# Mechanical Permit Set - Equipment Replacement Puyallup School District Central Kitchen Facility

**CENTRAL KITCHEN FACILITY**  
3607 17th St SW Puyallup, Washington  
SHEET TITLE: **MECHANICAL/ELECTRICAL  
SITE PLAN**  
SHEET NO.: **ME1.0**  
PROJECT NO.: **7351**

**CENTRAL KITCHEN FACILITY**  
3607 17th St SW Puyallup, Washington  
SHEET TITLE  
**1/4" KITCHEN PLUMBING  
PLAN B**

TITLE: PUYALLUP - QUOTE 24092 REV 8  FLOOR PLAN		UNLESS OTHERWISE SPECIFIED:	MODEL NUMBER	REV
		DIMENSIONS ARE IN INCHES AND ARE USED FOR REFERENCE ONLY.  ON-SITE VERIFICATION MAY BE REQUIRED.  DO NOT SCALE.	FLOOR PLAN	A
DATE: 3/14/2025	DRAWN BY: T. AFFELDT			SHEET: 1 OF 3

See related Plumbing Permit: PRPL20250734

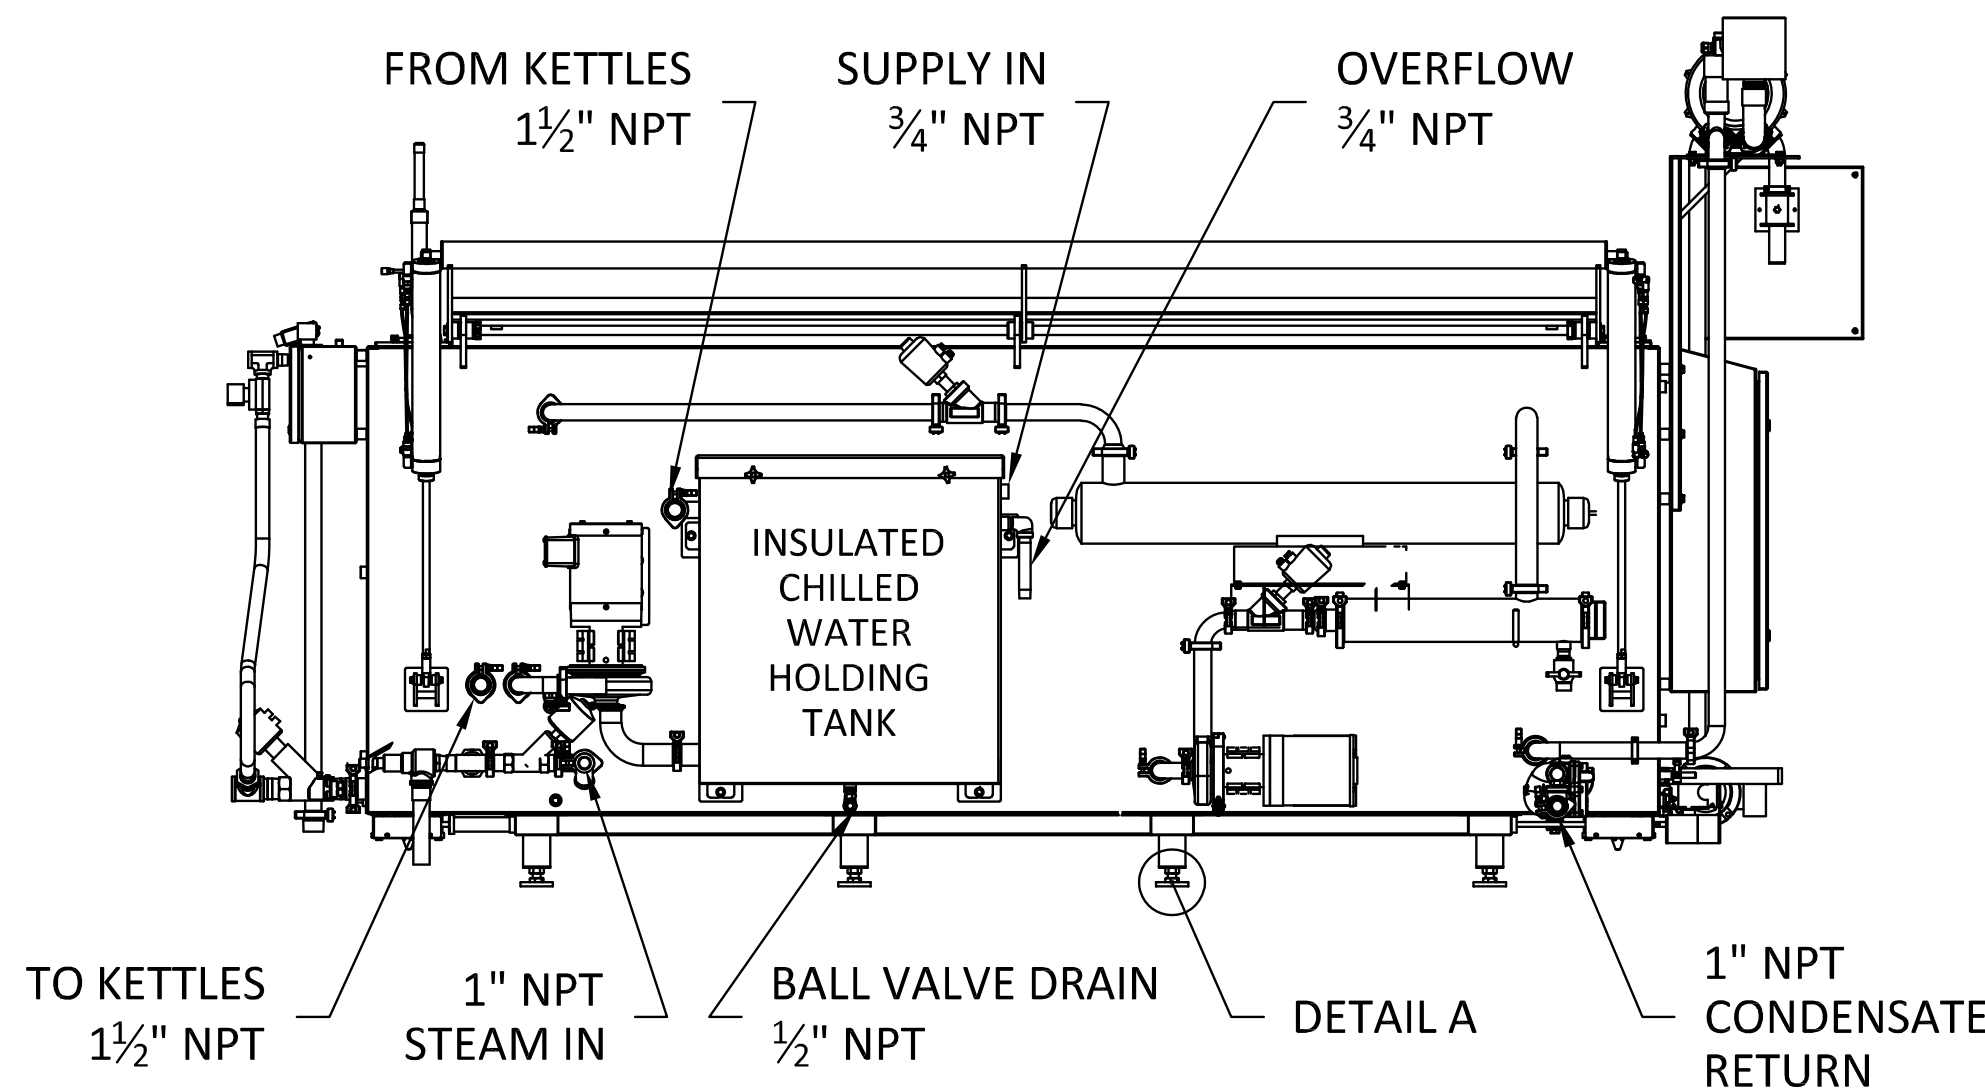
REVISIONS					PRMH20250723
ZONE	REV	DESCRIPTION	DATE	REVISED BY	
	A	RELEASED FOR APPROVAL	3/14/2025	T. AFFELDT	
	B	4X REFRIGERATION CONNECTIONS WAS 2X AND ADDED NOTE 4	4/7/2025	T. AFFELDT
